Meeting Date
30/12/2025

Client
PIDC

Project
Internal Electrical Distribution System & Allied Works - Block A (Package-II)

Annex - A

DRAWING TITLE:	MV SINGLE LINE DIAGRAM SHEET-1		
PROJ CODE	DRAWING NO.	REV.	01
01098	EA-01098-KIP-GE-EL-0003	REV.	01

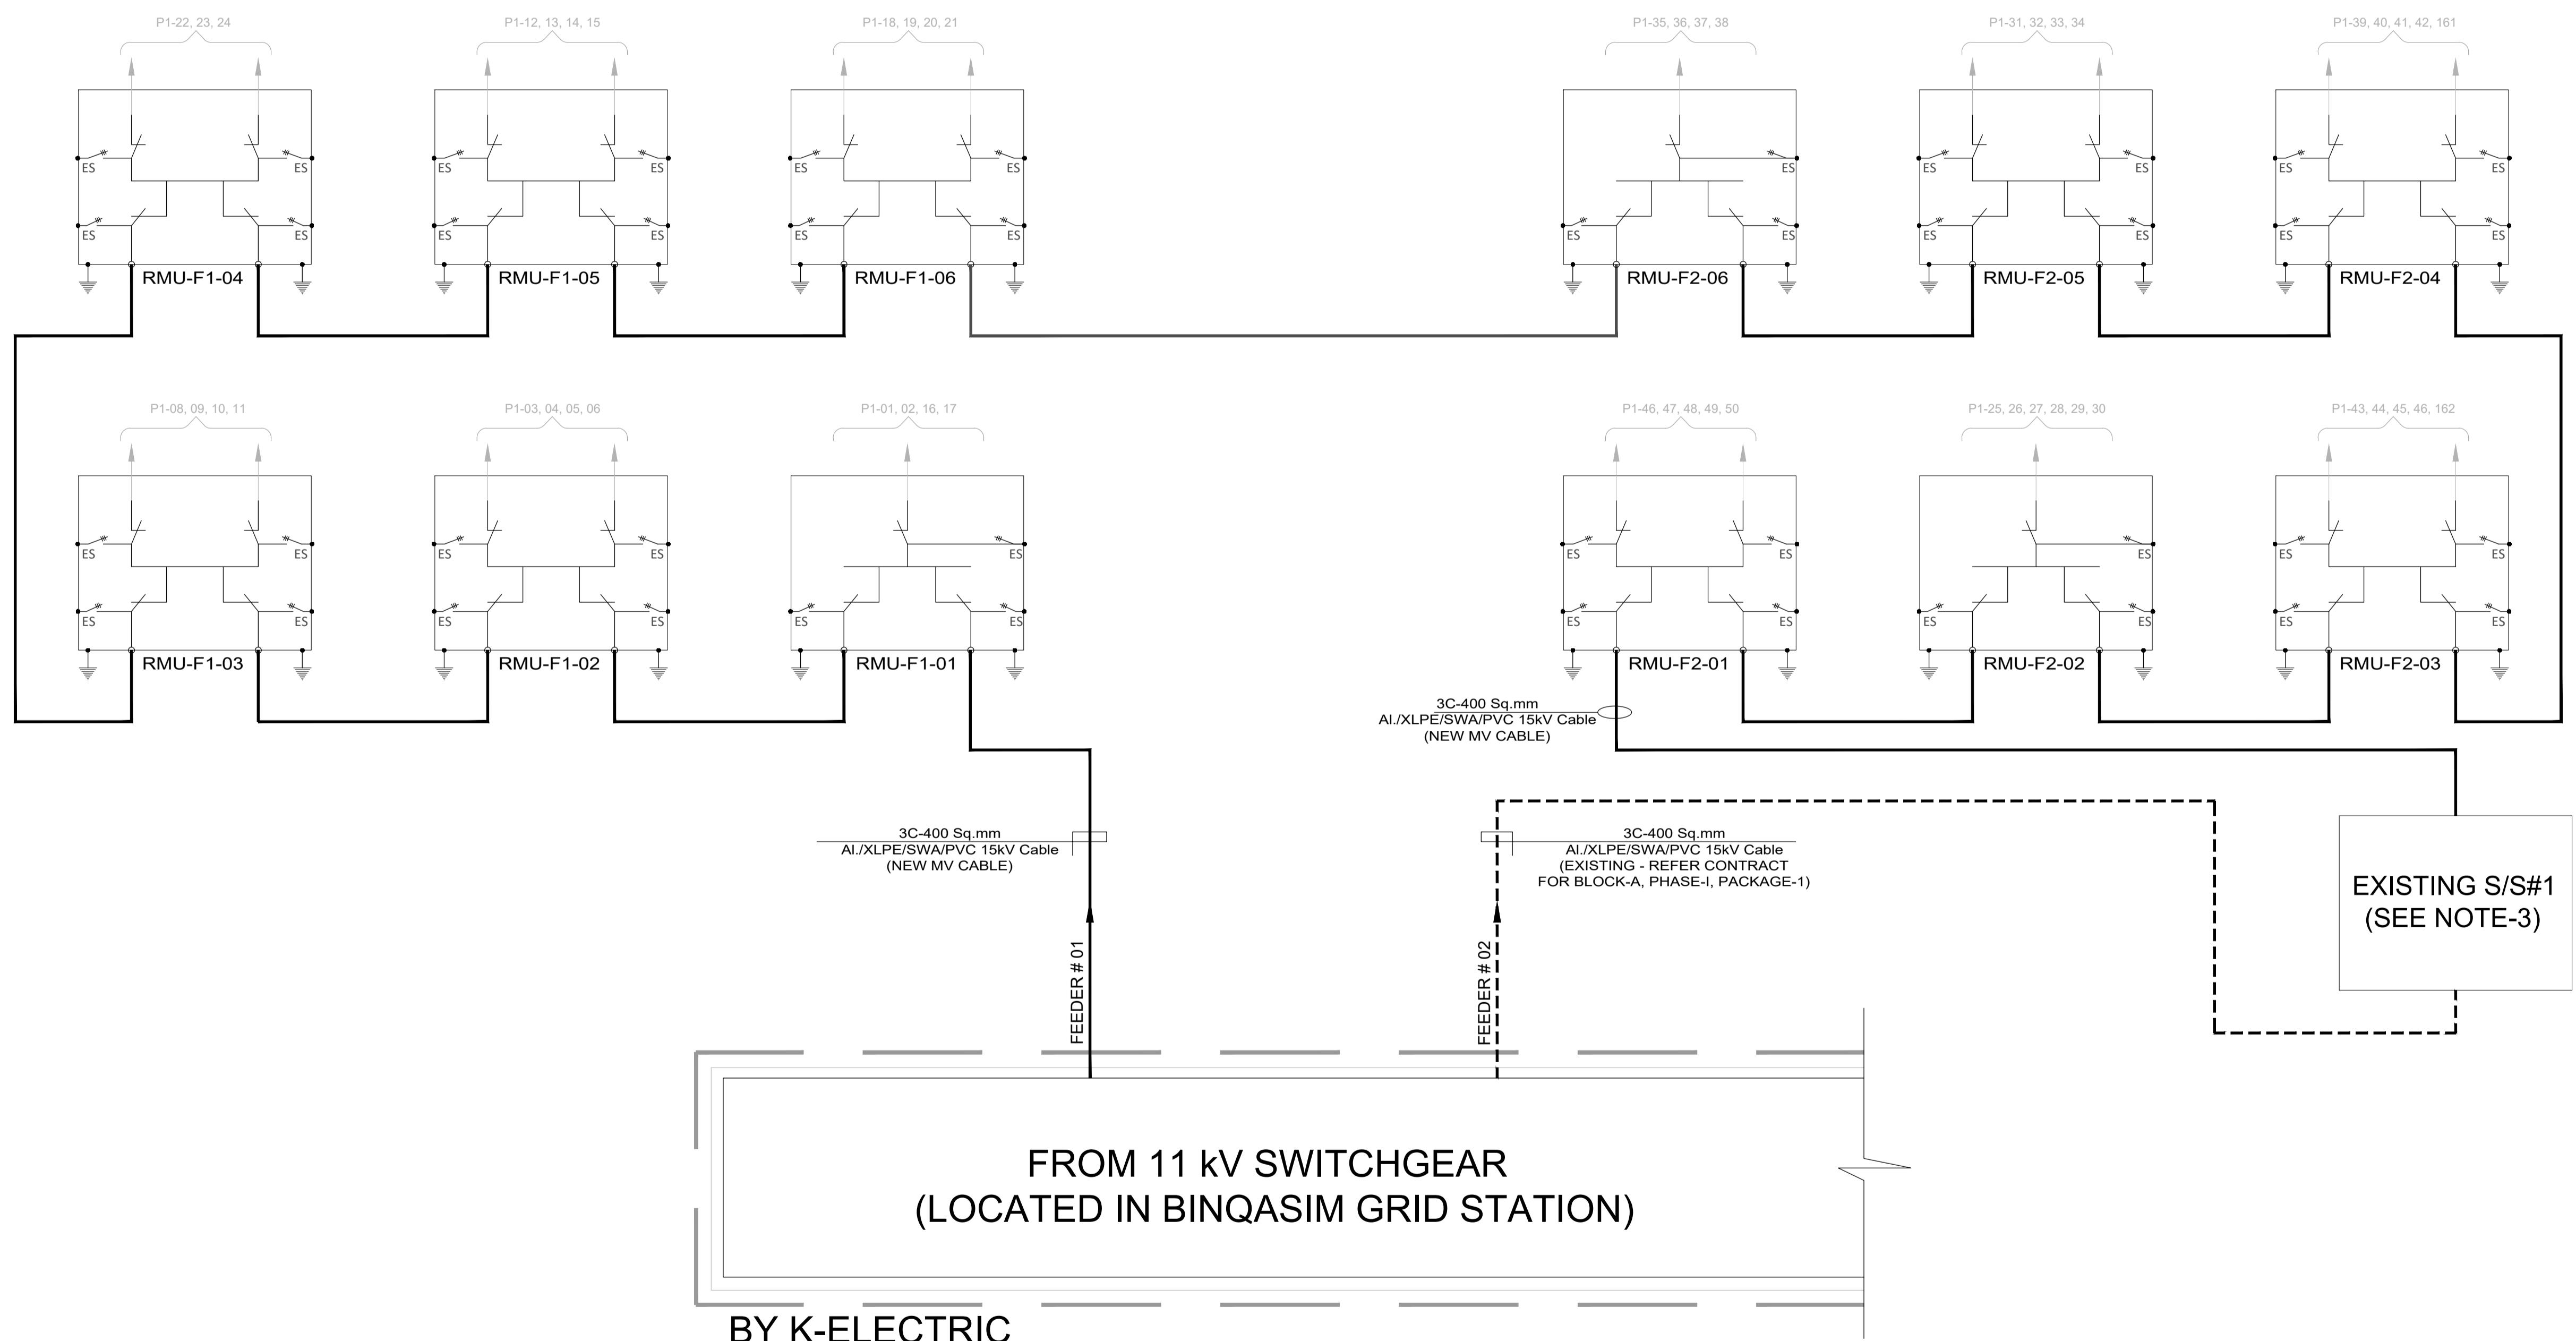
7	Standard detail drawings indicate that RMUs shall be as per WAPDA, whereas the BOQ indicates KE specifications.	It's a typo error, all RMUs and design shall be as per KE specifications. Revised drawings attached as Annexure A
8	The Bidder asked for the Detail-A for RMU Kiosk mentioned in the MV Drawing Notes.	Consultant confirmed that it will be a part of updated drawings. Attached as Annexure B
9	Bidder asked regarding NVR, which is mentioned as 64 channels in BOQ and 100 channels in specifications.	BOQ shall be followed.
10	Bidder asked regarding the cable marker material.	Follow the MES Schedule, as this is a schedule item.
